Docket Item #2-A & B
DEVELOPMENT SITE PLAN #2004-0005 (2-A)
SUBDIVISION #2004-0005 (2-B)
STREET NAME CASE #2004-0001 (2-A)
OAK GROVE

Planning Commission Meeting
May 6, 2004

ISSUE: Consideration of a request for a development site plan to subdivide the property into 10 lots, to construct single family homes and to name a new public street.

Open Space if City were to Purchase Lot 9

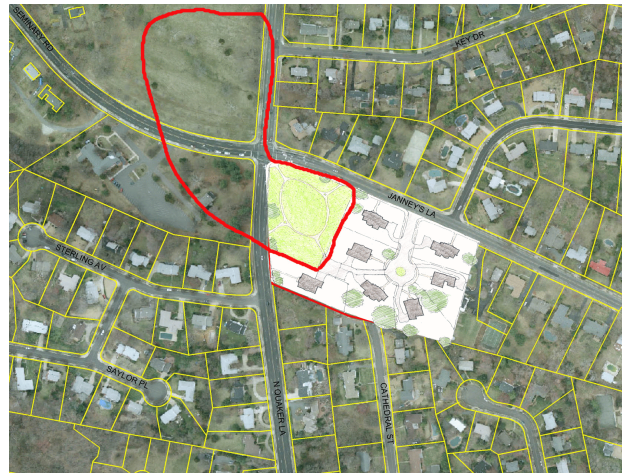
The purchase of an additional lot would result in approximately 75,000 sq.ft. (1.7 acres) of open space. Staff initially recommended that such a lot purchase should be acquired on Quaker Lane to visually connect to the adjoining open space on Quaker Lane. Such a location also would allow the open space to be visible to the most people, creating the greatest impact, both visually and functionally relating to the open spaces to the west/northwest. If this lot was acquired it would revise the plan as generally depicted in the graphic.

Proposed Drainage Pattern Map

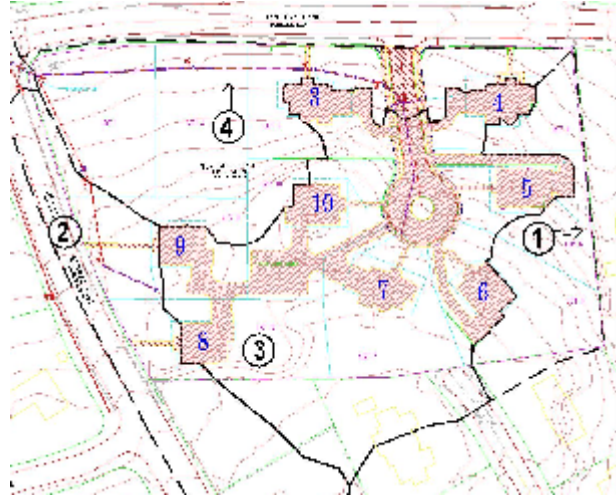
Under the development plan most of the site run-off from areas 1, 3 and 4 will be collected by underdrains, roof drains and storm sewer to convey the surface run-off to an existing underground storm sewer conveyance system. This will substantially reduce the existing surface run-off sheet flowing off-site. Stormwater management detention practices will be implemented, if necessary, to make sure that the proposed run-off will not exceed the existing run-off flowing into the existing storm sewer system.
